# UNITED STATES PATENT AND TRADEMARK OFFICE

**Advisory Action  
Before the Filing of an Appeal Brief**

10/633,523

**Notice of Non-Compliant  
Amendment (37 CFR 1.121)**

**FIG.9**

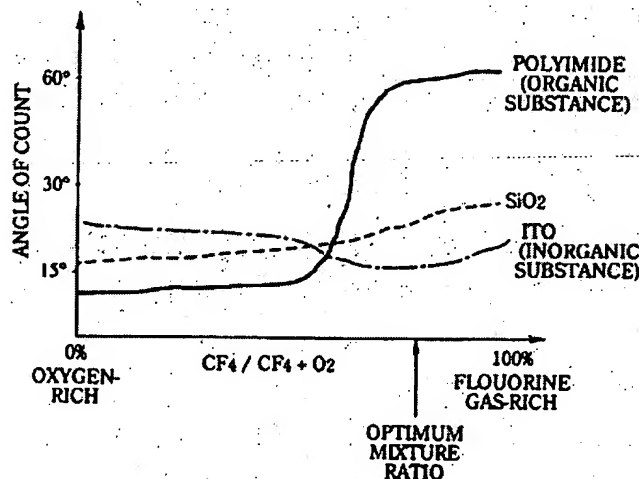
*"Seki, et al.'s 4th embodiment (Fig. 9 and [0178]) does not state that the claimed dry etching process is performed prior to the use of CF<sub>4</sub>/O<sub>2</sub>, and therefore such constitutes neither a description nor a suggestion of feature (b). In this regard, Applicants respectfully submit that Seki, et al.'s Fig. 9 shows that when a gas mixture is used at the optimum ratio, the effect of plasma treatment using fluorine gas is suppressed and the contact angle of polyimide is reduced"*

Regarding figure 9 of Seki, the examiner does not understand how applicant arrived at their conclusion. Figure 9 shows that Seki's optimum  $\text{CF}_4:\text{O}_2$  ratio correlates closely to applicant's claim limitation that requires forming a plasma from a mixture of a halogen gas and  $\text{O}_2$ , wherein the amount of  $\text{O}_2$  gas is not greater than 30%. Contrary to that which was argued by applicant, figure 9 shows that the contact angle with respect to polyimide, increases with the fluorine treatment.
